行政院及所屬各機關出國報告
(出國類別：其它)

汰換高雄、馬公終端航管雷達案 第一次合約管理暨系統設計審查會議

MINUTES of MEETING		Ref: ARS_PMR#1_SDR/MoM03 Date: June 25 th , 2010 Author: T DELALANDE Approved:
CONTRACT : No. Contract ref. 10-GF3-0002			
DATE : June 14 th - 25 th , 2010		PLACE : THALES, Ymare	
SUBJECT: Program Management Review and System Design Review			
Attendees: Mr. Shun Fa Chen – ANWS, Mr. Chin-Yu Kang – ANWS, Mr. Chun-Tsai Lee – ANWS, Mr. Shang-Tien Tsai – ANWS, Mr. Alistair Falconer – MITRE Corporation, System Engineering / ANWS consultant Mr. Thomas Delalande – THALES, Program Manager, France Mr. Jean Fumeux – THALES, Logistic Manager, France Mr. Hervé Dutheil – THALES, Radar Product Manager, France Mr. Christian Vidal – THALES, Civil Works, France Mr. Patrick Lorot – THALES, Product Engineer Mr. Sylvain Colin – THALES, Product Engineer Mr. Guillaume Cornu – THALES, Product Engineer Mr. Pascal Jezequel – THALES, Product Engineer Mr. Hong-Yu CHEN - TSTI Company Ms. Juan-Juan Min – CY AND Company

ENCLOSURE 2**ANWS comments and THALES answers**

Magong radome design proposal by THALES

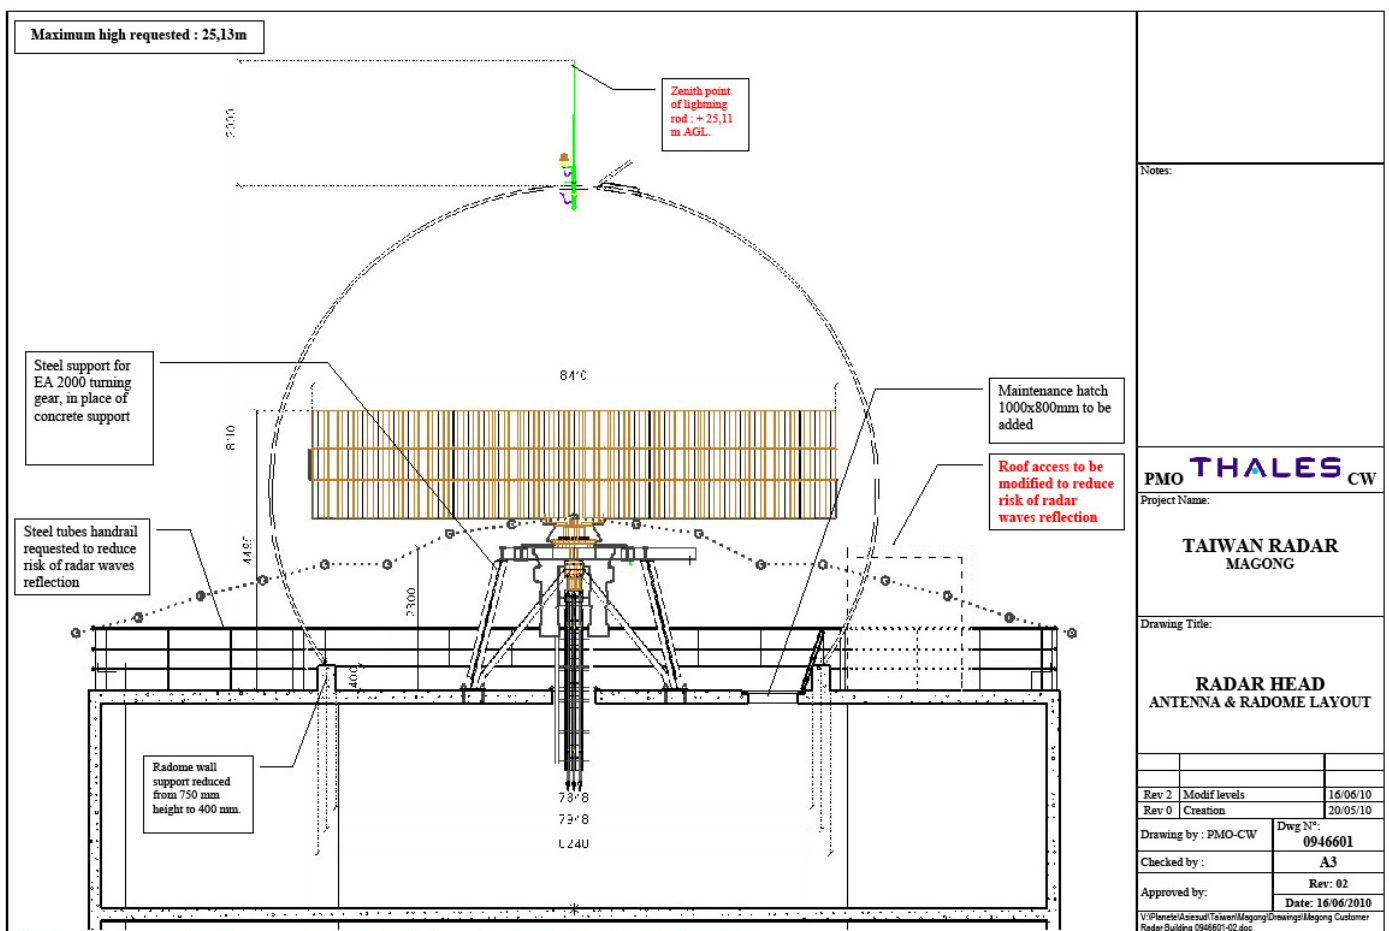
a. 為達到主動式避雷針對雷達機房保護效果，THALES 公司建議避雷針長度至少要 2m，與馬公助航臺確認該臺址過去並無淹水紀錄，經細部討論後建議將球罩女兒牆高度由 75cm 降低 40cm，另將 1 樓距地面高度由 1m 調整為 75cm，調整後除可將 2m 主動式避雷針架設於球罩頂外，並可滿足禁限建及天線平臺 350 公尺內不得有建物高於天線平臺之規定，本總臺同意 THALES 於球罩頂安裝 2m 高之主動式避雷針。

for easy radar installation and maintenance for later. b. It was suggested by THALES that the height of the parapet on the 4th floor to be 90cm, railing to be put on top. c. The protruding structure on the 4th floor entrance will be changed to become a push up door from the ground. d. THALES will provide a 2m ESE lightening rod, and propose to modify the height of parapet for the radome from 75cm to be 40cm (with inserting steel rods being 30cm), the foundation height for the first floor is modified from 1m to be 75cm. A confirmation will be made to THALES, after discussions made by ANWS and its architect by 31/07/2010. See enclosure 6. e. THALES will provide the templates for radome inserting steel rods and the procedures to follow. f. ANWS has to install a 64A 3P/4w breaker, the same time with the UPS in the equipment room on the 4th floor. 2. Site readiness It is estimated by ANWS that the building will be ready by mid 2011. 3. Installation steps THALES agrees to provide two 230/400V transformers. They will be installed by the equipment room contractor. 4. Equipments to be provided by ANWS Only GFE equipments (power supplies through UPS, communication lines) will have to be provided by ANWS. 5. Test a. Test Readiness Review (TRR) will be held prior to SAT. b. Prior to commencement of confidence tests, a brief discussion between THALES and ANWS will take place, to cover the testing plans, acceptable status, rejecting status...all related issues. During the confidence test period, THALES representatives will stay on site for the entire period. Daily status check lists will be provided by THALES. Such lists will be signed by both THALES and ANWS representatives each day. 6. UPS with capacity of 40KVA is sufficient. 7. UPS status will be monitored on the RCMS. UPS used at Magong will have the same specifications as the ones used at Kaohsiung. 8. THALES will provide an installation plan by 31/10/2010.

NOTE : In order to be compliant with ICAO recommendation, height of building basement must be reduced from +1,00 m AGL, to + 0,75 AGL
